# UNITED STATES PATENT AND TRADEMARK OFFICE

10/562,467

Yukio Miyairi

## **DETAILED ACTION**

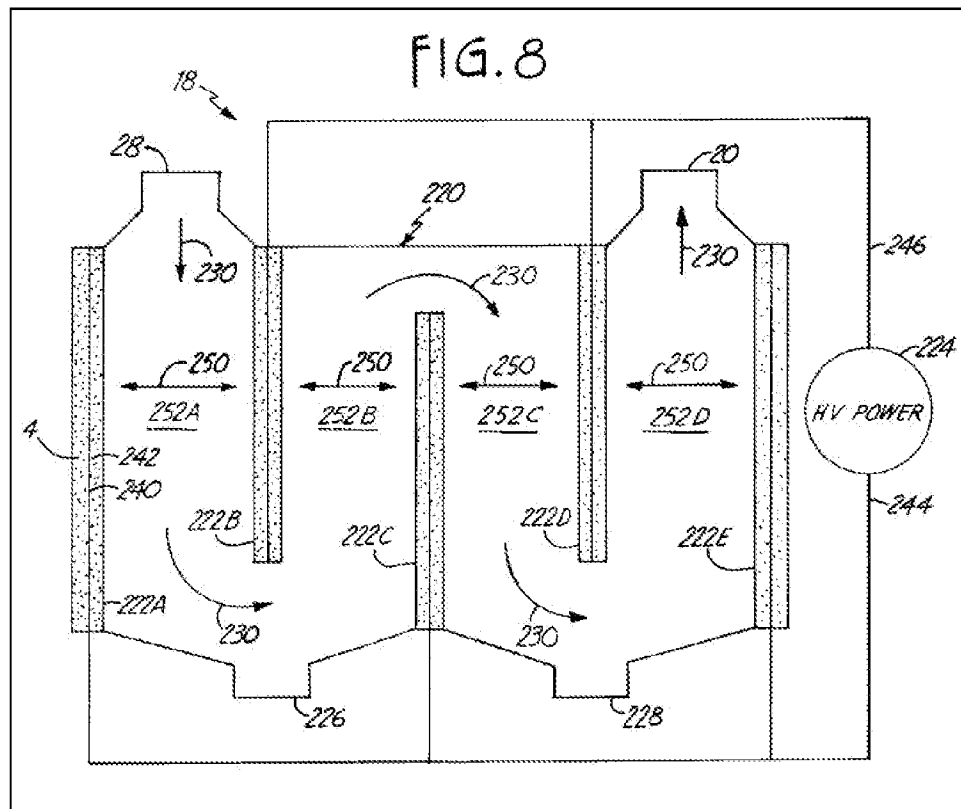
Regarding claim 11, RUAN teaches a plasma generating electrode comprising:

- two or more electrodes disposed to face each other with each of the electrodes having both a fixed-end portion and a free-end portion (see electrode panels 222A–E and col. 6 lines 49-51 teaching the electrodes facing each other to generate plasma in a non-thermal plasma reactor having both a fixed-end portion and a free-end portion);

- holding members for holding the electrodes at a predetermined interval and capable of generating a plasma by applying a voltage between the electrodes (see housing 220 and col. 6 lines 49-57 which teaches housing 220 holding electrode panels 222A–E at a set interval from each other for generating plasma by an application of a voltage from high voltage power source 224); and

- a connection terminal for electrical connection to the fixed end portions of the electrodes (see terminals 244 and 246 and col. 6 lines 63-66 discussing the power source being electrically coupled to the electrodes at the fixed end portions);

- wherein at least one of the electrodes facing each other has a plate-shaped ceramic body serving as a dielectric body and a conductive film disposed inside the ceramic body (see dielectric material 242 and 4, conductor 240, and col. 6 lines 57-63); and
- the holding members fix the fixed-end portions of the electrodes facing each other in the state of a cantilever in such a condition that the electrodes are held by the holding members in the state of cantilevers of the different directions alternately at a predetermined interval as a whole (see electrode panels 222A–E and col. 6 lines 63-67 showing alternating electrode panels being held in a cantilever state with alternating polarity). See figure 8 below.

Regarding claims 17 and 18, RUAN teaches the plasma generating electrode where the connection terminal is connected to the fixed end portions of the electrodes (see terminals 244 and 246 and col. 6 lines 63-66 discussing the power source being electrically coupled to the electrodes at the fixed end portions). See figure 8 above.

- a case body having a passage of gas containing a predetermined component and being capable of making the predetermined component contained in the gas react with plasma generated by the plasma generating electrode when the gas is introduced into the case body (see housing 220 and col. 3 lines 12-15 and col. 6 lines 42-46 teaching the housing being adapted so as to pass a flue gas through the reactor to remove various hazardous oxides in the gas). See figure 8 above.
